**AmerenUE**  
Callaway Plant

**Subject:** AmerenUE, Callaway Plant Unit 2 (NRC Docket No. 52-037)  
Response to RAI No. 9 (e-RAI 2484), Revision 0,  
Section 09.05.02 – Communications Systems

**Response to RAI No. 9 (e-RAI No. 2484), Revision 0**

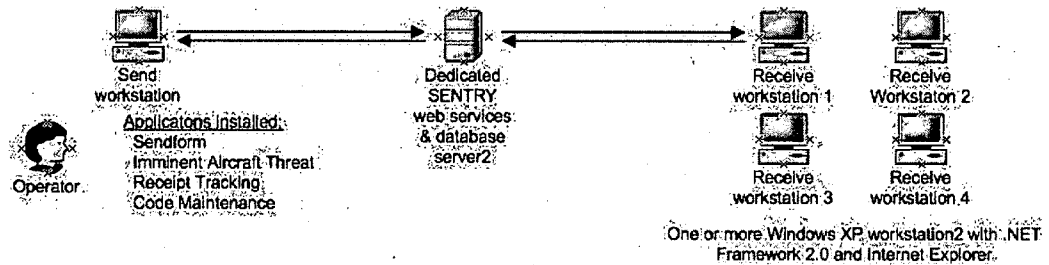
Provide the functional design of the SENTRY system used for emergency communications with state and local authorities as required by Appendix 10 CFR 50.47(b)(8).

SENTRY Version 3.0, Callaway Plant Notification System, is a custom-built suite of VB .NET client server applications that execute within an isolated workspace. The suite is divided into multiple applications to provide flexibility in deployment. SENTRY is designed to comply with the requirements contained in NEI 04-04, Cyber Security Program for Power Reactors, Revision 1.

SENTRY version 3 runs within a Workspace to isolate it from the rest of the domain.

The preceding image is SENTRY version 3 in its simplest terms, the applications in the SENTRY suite are:
